WEST BOUNTIFUL PLANNING COMMISSION

**THE PLANNING COMMISSION WILL HOLD A REGULAR MEETING
AT 7:30 PM ON TUESDAY, MAY 25, 2021 AT THE CITY OFFICES**

RE: Highgate No. 2 Phase 1 Subdivision - Final Plat (waiver for small subdivision)

RE: Doug's Corner Subdivision - Final Plat (small subdivision)

STREET CROSS SECTION

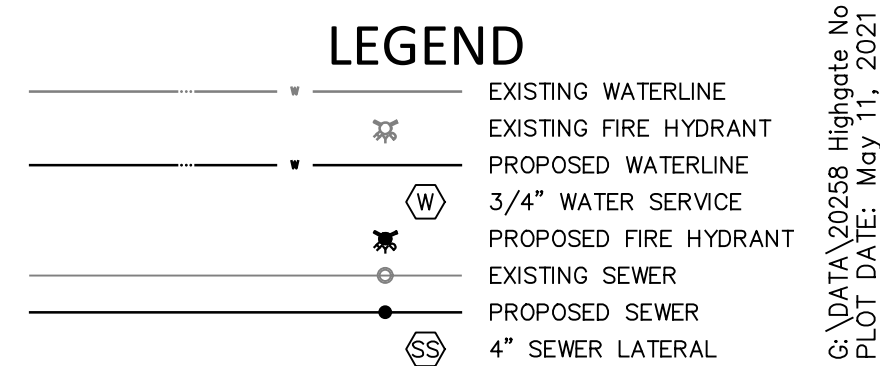
1. Revise street cross section to indicate 5" of asphalt (currently shows 4").
2. Provide design TBC labels and existing TBC labels at connection to existing Wellington Avenue.
3. All sidewalk shall be minimum 6" thick concrete over a minimum of 6" base coarse.
4. Minimum 6" base coarse under all curb and gutter.

Sheet C-500-Grading and Utility Plan

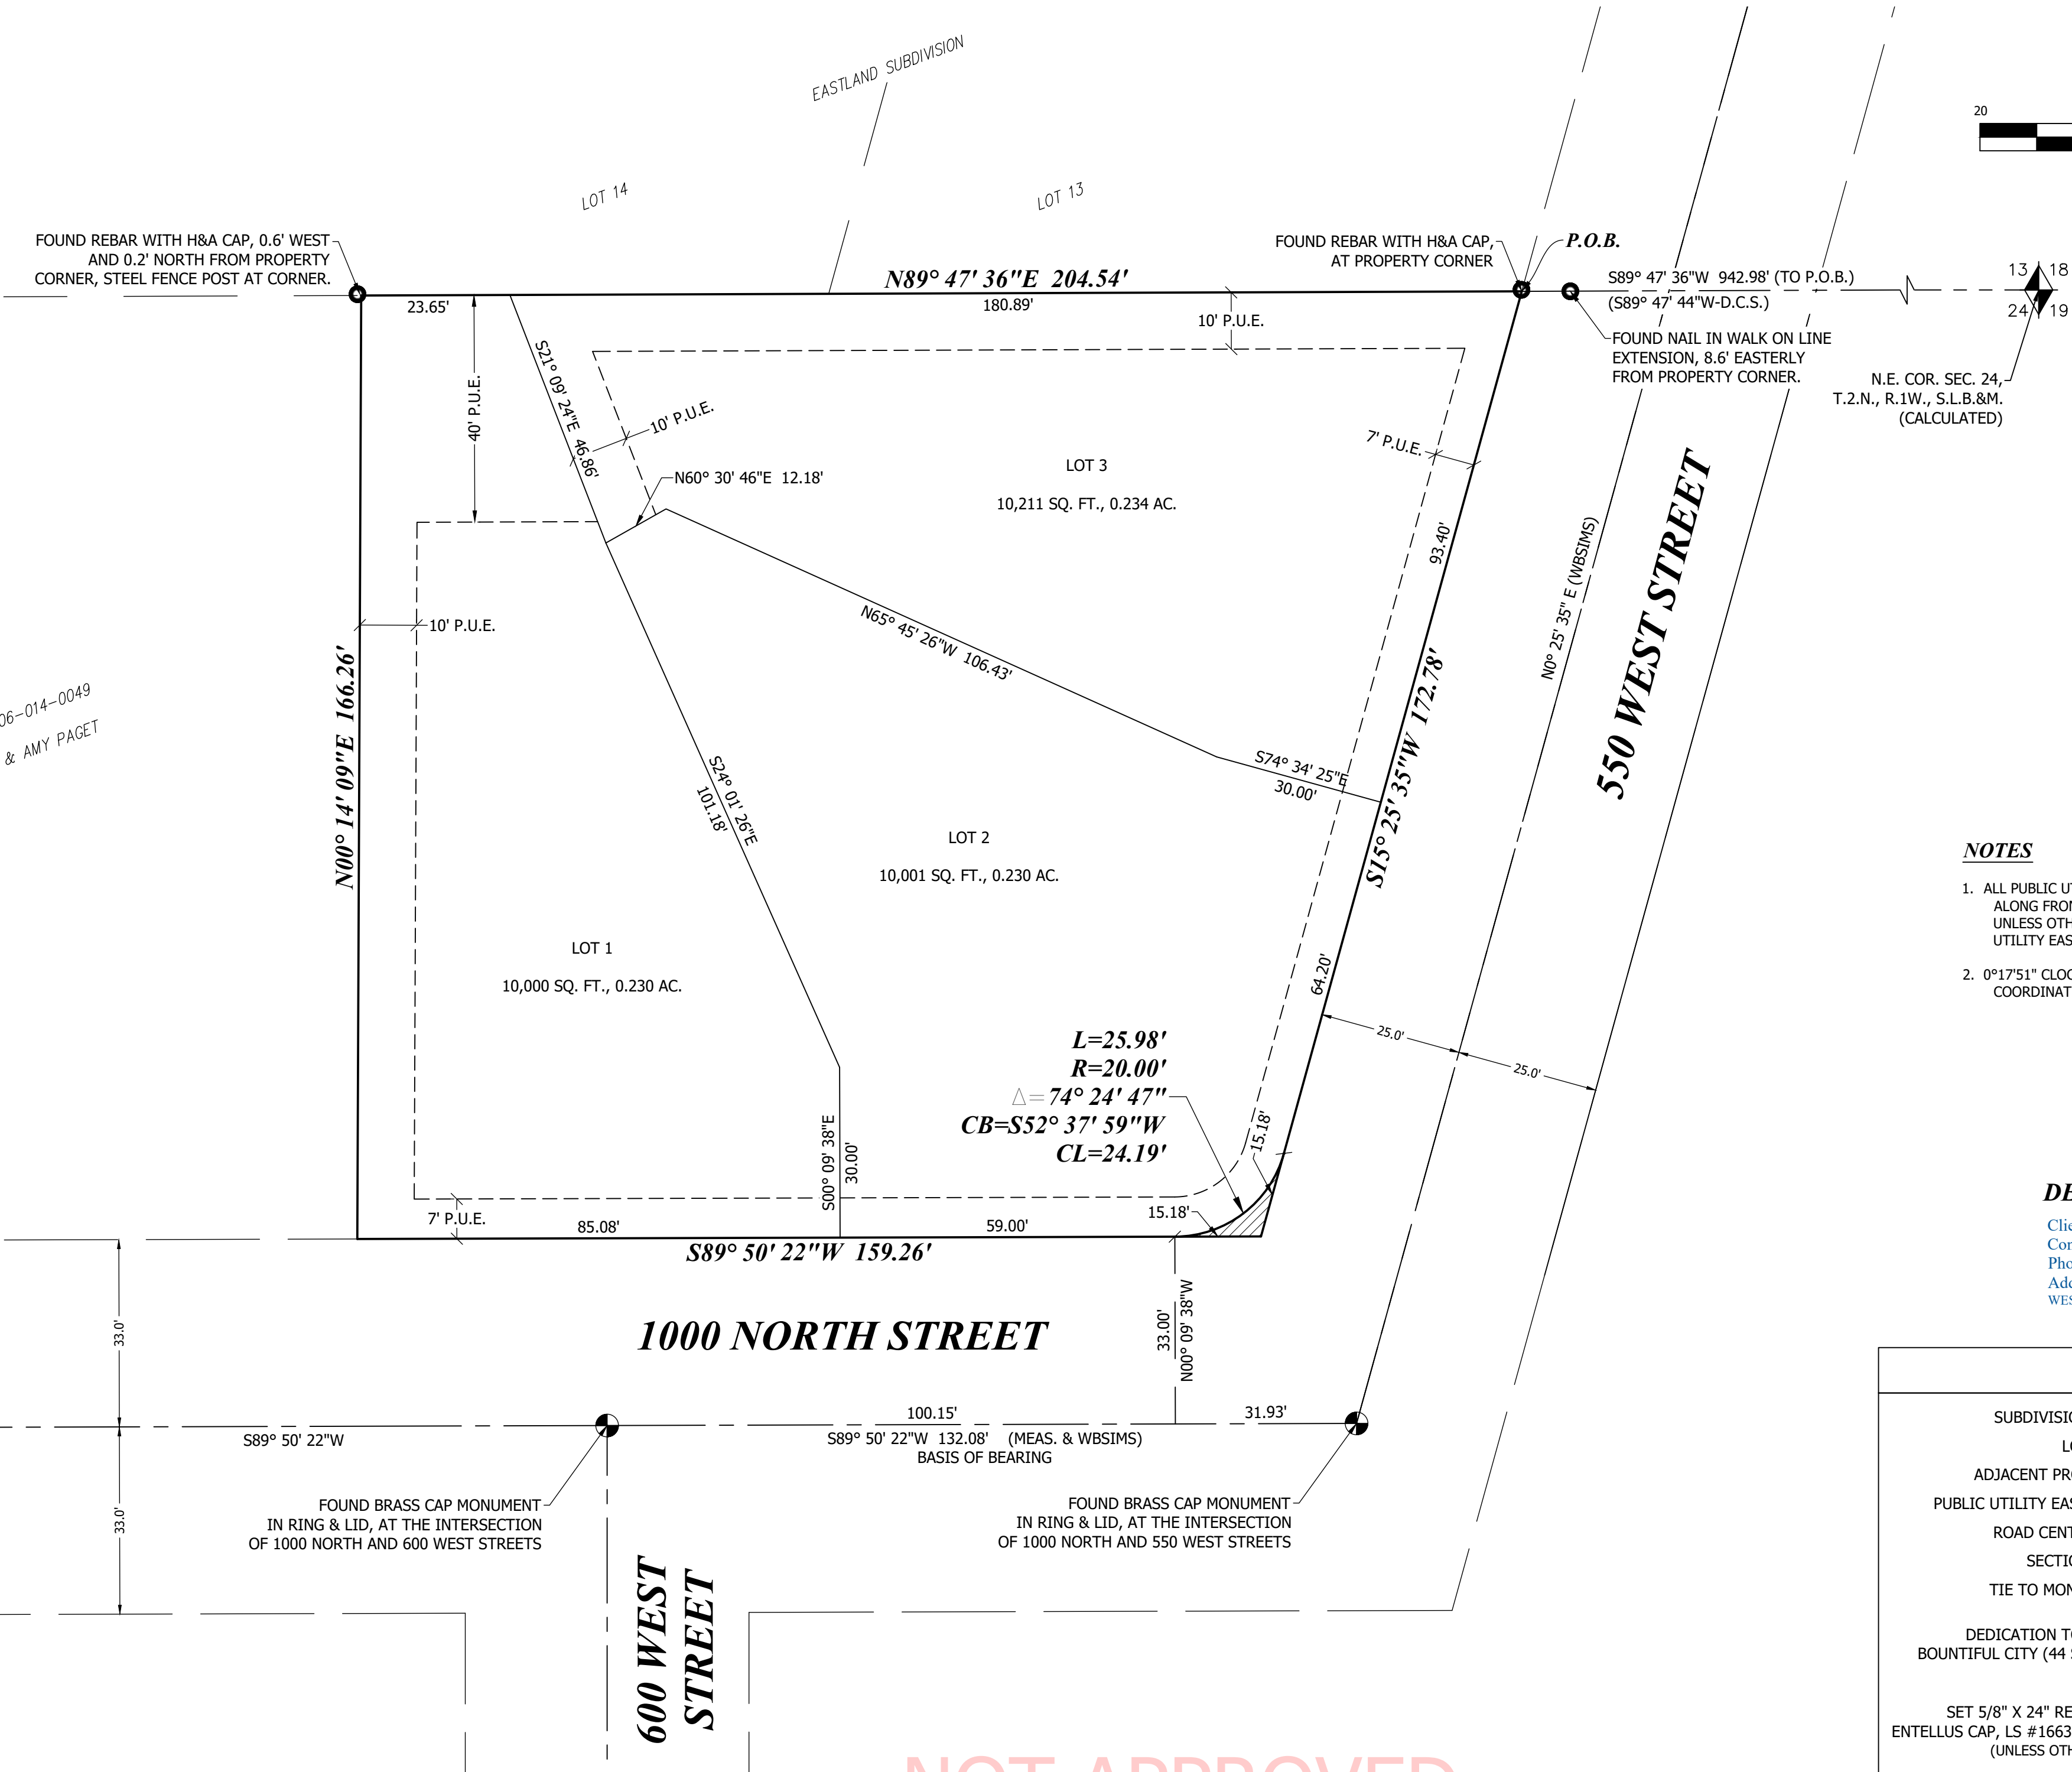
2. Culinary Water service laterals to lots are shown as 1" size - revise to ¾" service diameter.

DOUG'S CORNER SUBDIVISION
LOCATED IN THE NORTHEAST QUARTER OF SECTION 24,
TOWNSHIP 2 NORTH, RANGE 1 WEST, SALT LAKE BASE & MERIDIAN
WEST BOUNTIFUL CITY, DAVIS COUNTY, UTAH
APRIL 2021

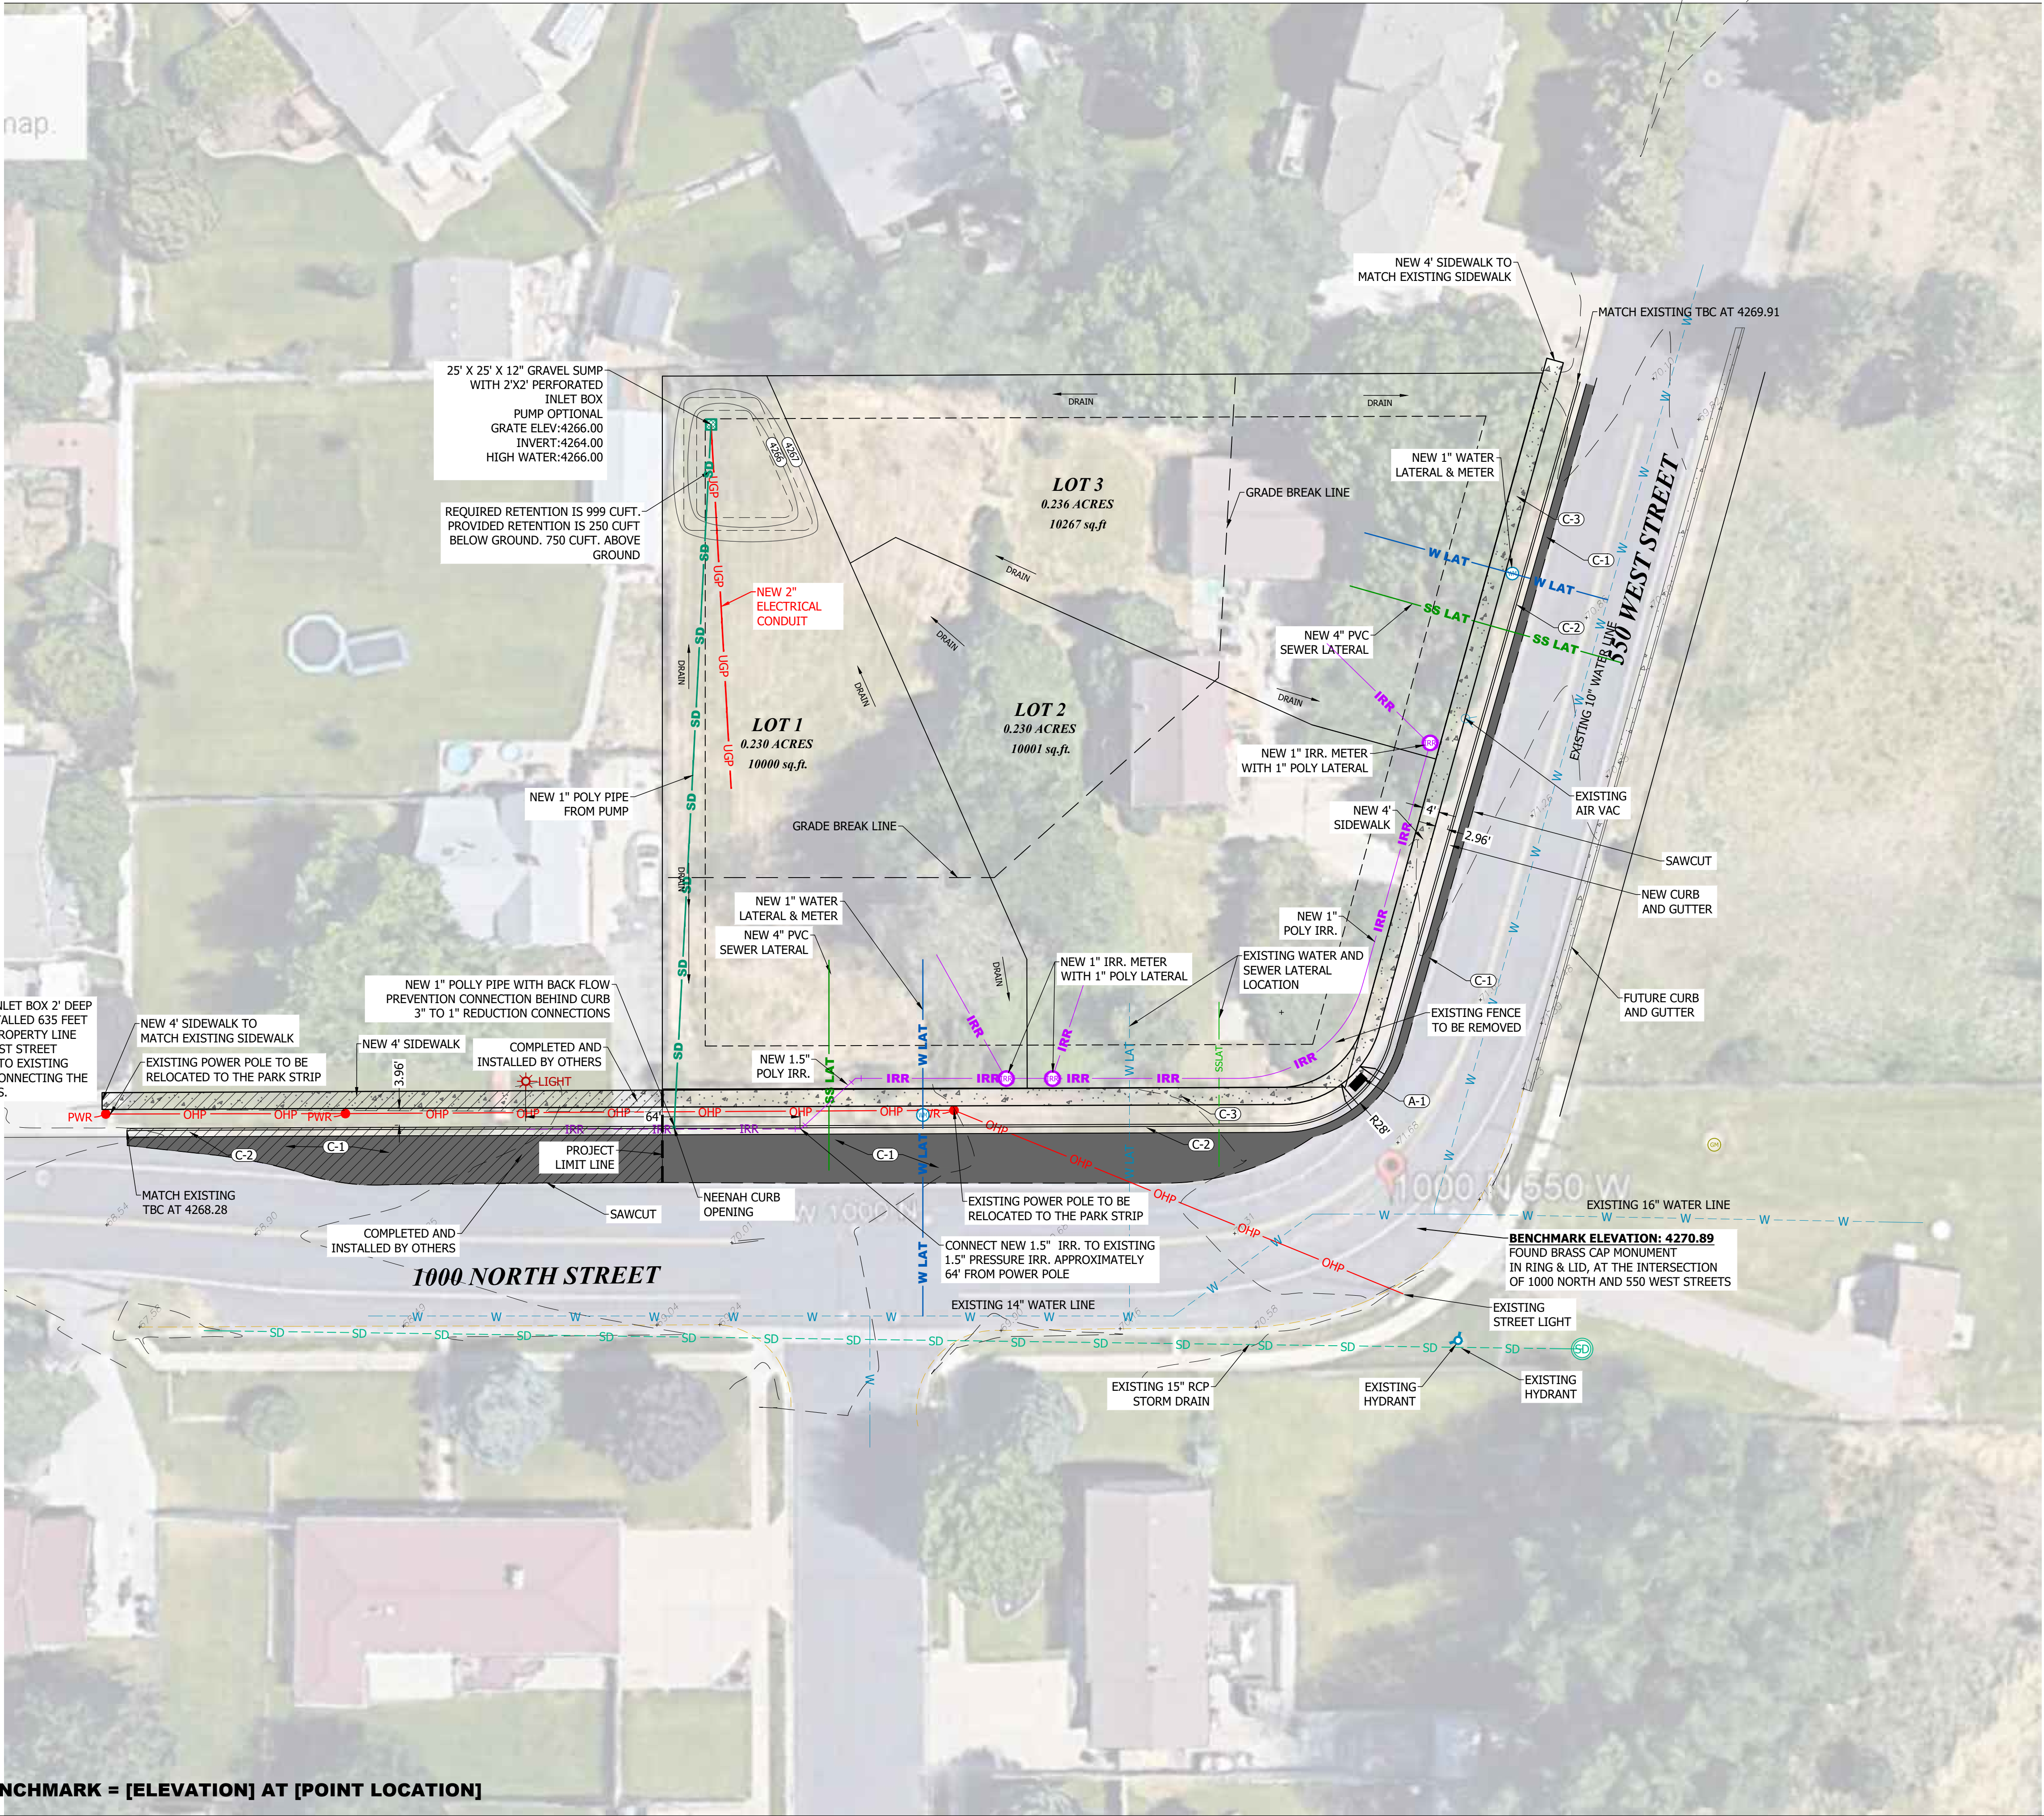
1. An accurate and complete survey to second order accuracy shall be made of the land to be subdivided.
2. **The plat shall show accurately drawn boundaries and shall note the proper bearings and dimensions of all boundary lines of the subdivision.**

4. **All lots, blocks and parcels offered for dedication for any purpose shall be delineated and designated with dimensions, boundaries and courses clearly shown and defined.**

7. **All streets, including named streets, within the subdivision shall be numbered in accordance with and in conformity with the adopted street numbering system adopted by the city.**
